City of Sebastopol Planning Department

Re: 7716, 7760 Bodega Ave./Permit Number 2021-010
Woodmark Apartments Project – Incompleteness Review

Date: April 15, 2022
Project: SEB071
To: Mr. David Hogan
City of Sebastopol
From: Cameron Nye
cnye@w-trans.com
Subject: Review of Updated Materials for the Woodmark Apartments SB 35 Application

Attachment C
COMMENTS & DESIGN RECOMMENDATIONS

Image 1 of Number 3.

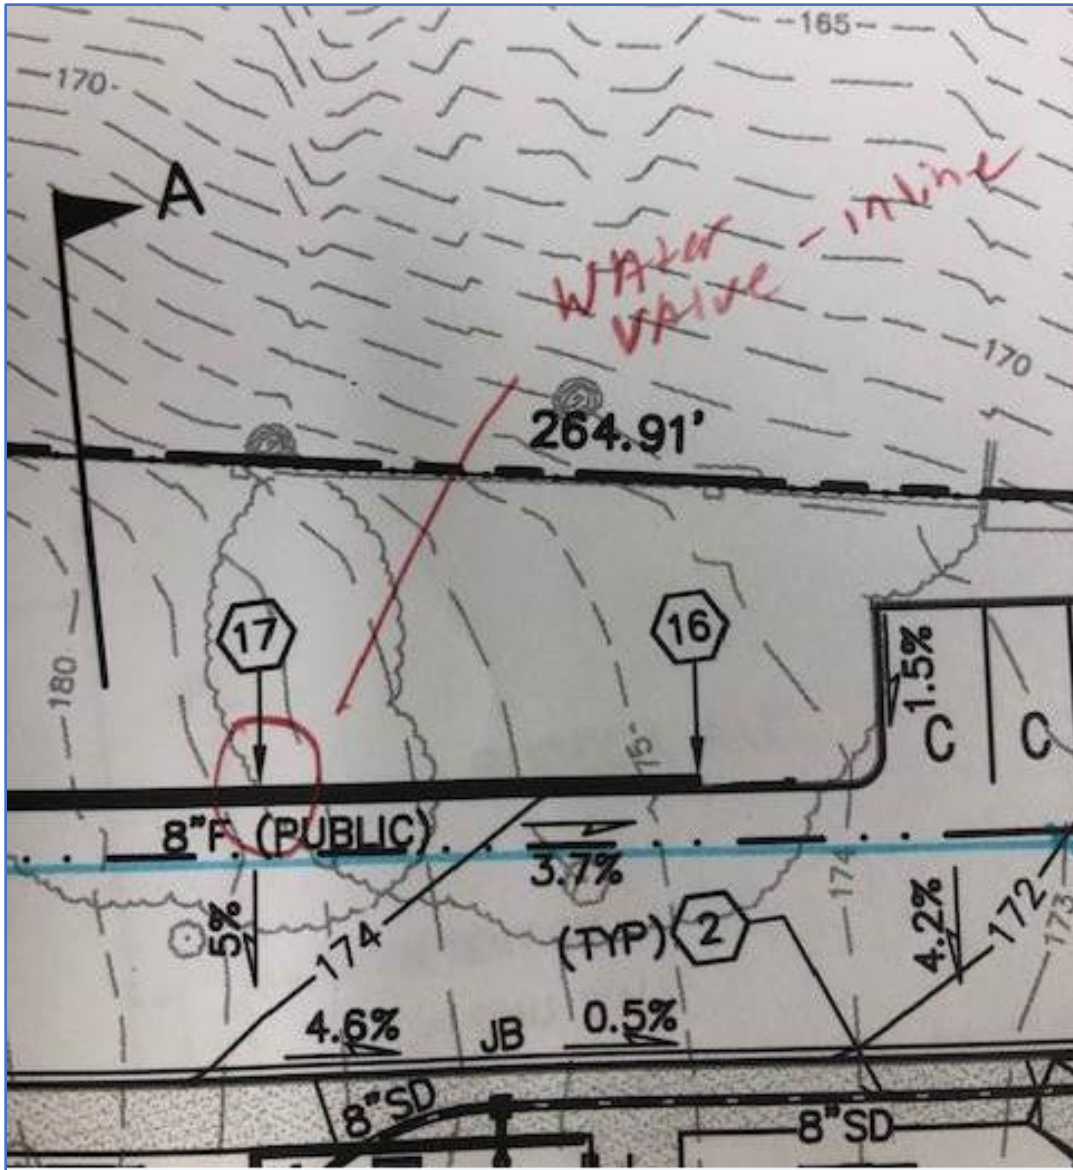
3. To allow the different sections of the fire hydrant loop to be selectively turned off (as opposed to being either all on or all off), the next series of images identify the locations to add isolation valves to the system.

PRELIMINARY GRADING, DRAINAGE AND UTILITY PLAN
WOODMARK APARTMENTS
3.59 ACRES
7716 AND 7760 BODEGA AVENUE
SEBASTOPOL, CALIFORNIA
APN 080-230-067
A/PF 004-211-007
JANUARY 2021

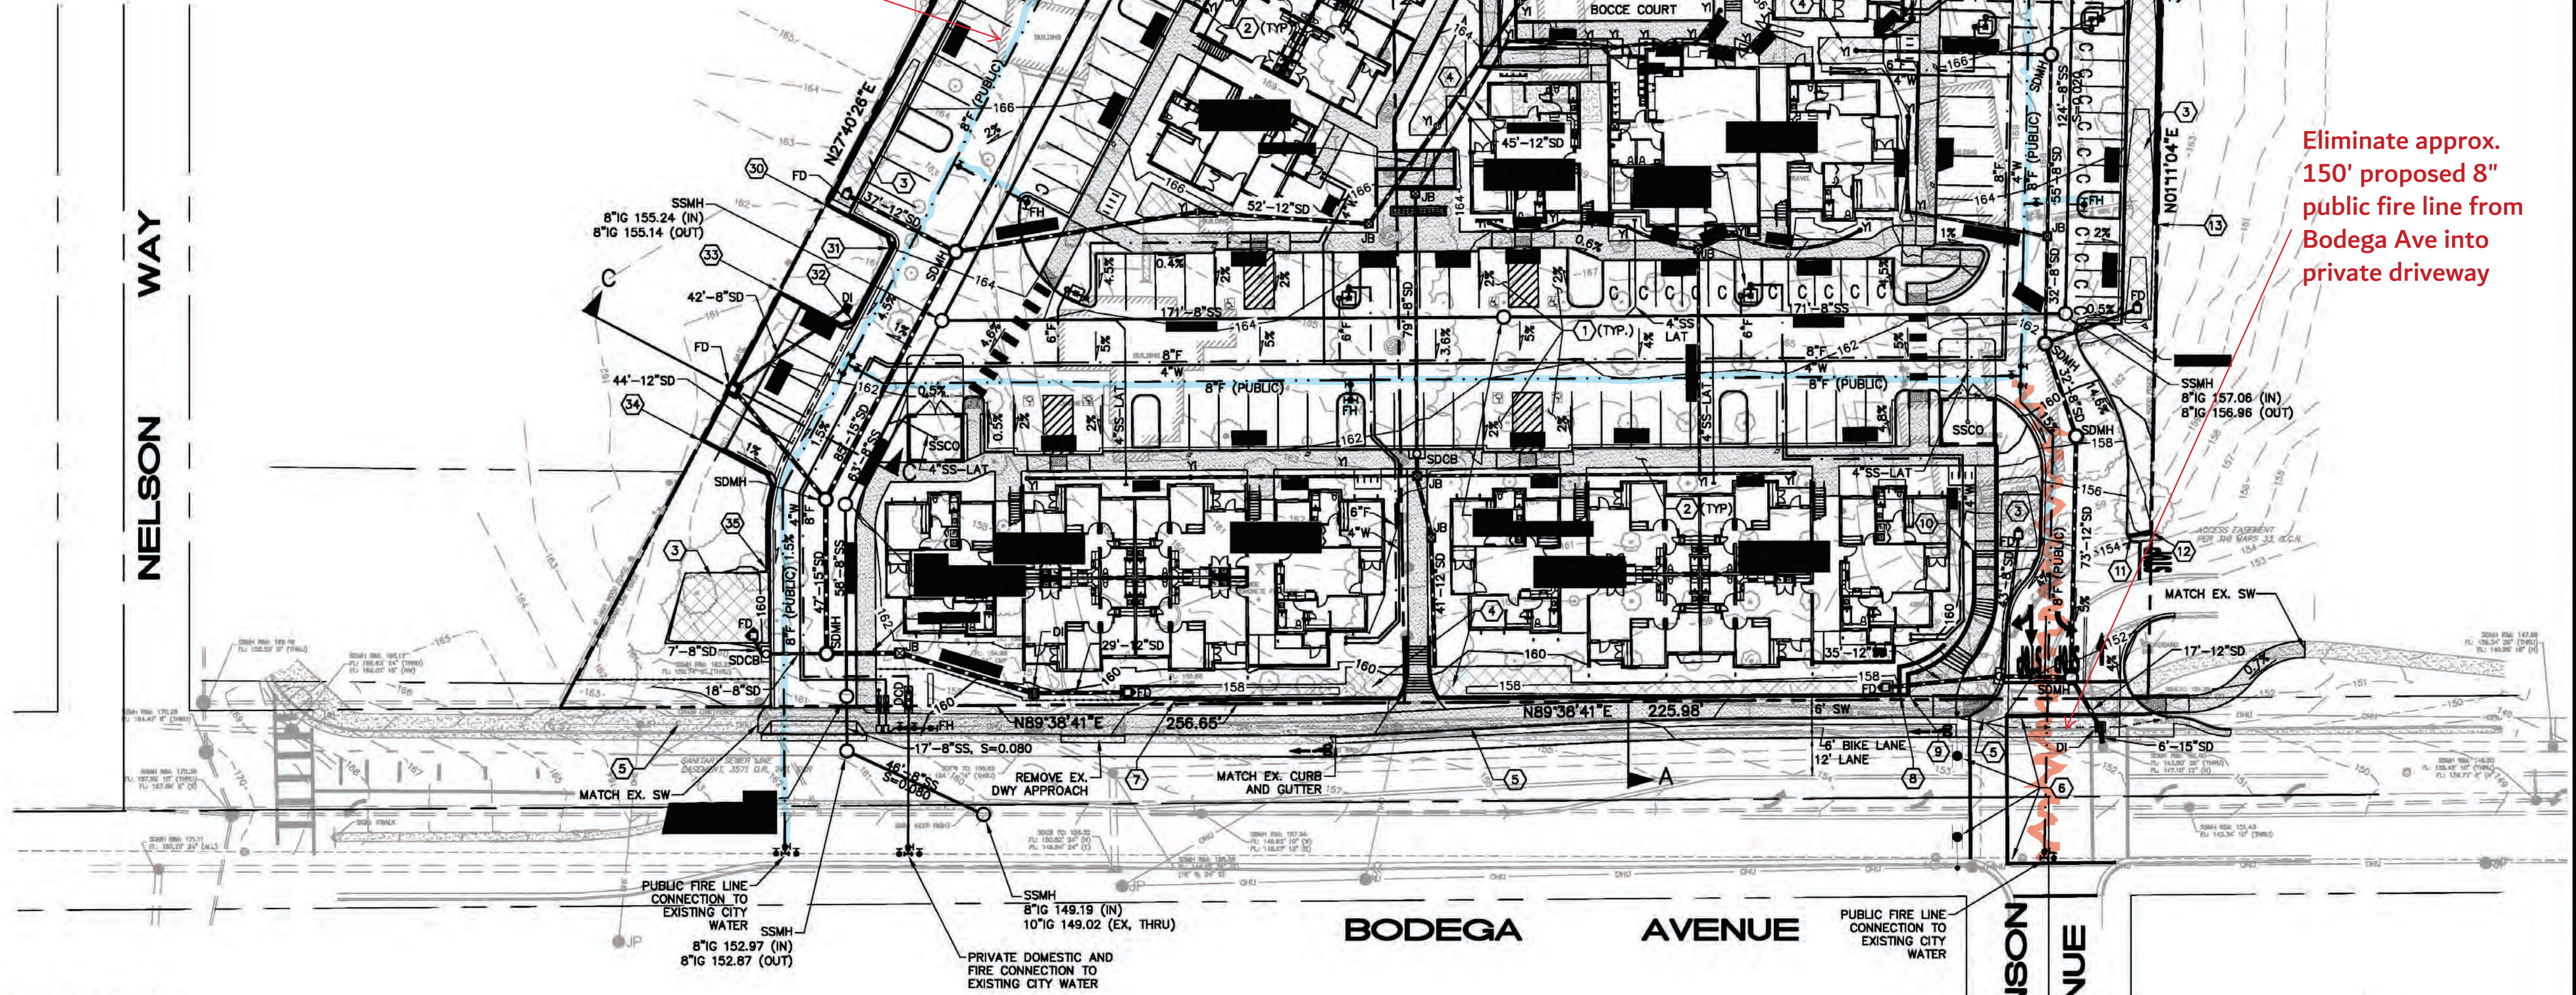
blue line is proposed new 8" public fire line

Extend waterline (approx. 40') from existing blowoff to new 8" public fire line

Eliminate approx. 150' proposed 8" public fire line from Bodega Ave into private driveway

However, City staff has identified an alternative approach that could address the design issues associated with the Blow Off and potentially reduce future development costs in a subsequent application. The solution would involve connecting the end of the Blow Off to the proposed fire water supply main. This could eliminate the need for approximately 150 feet of 8" line entering the site from Bodega Avenue and eliminate another trench in that area. A diagram of this design solution is included in Attachment D to this letter. If this alternative approach is acceptable, please provide a written confirmation that this alternative project design can be made a condition of approval on the project.
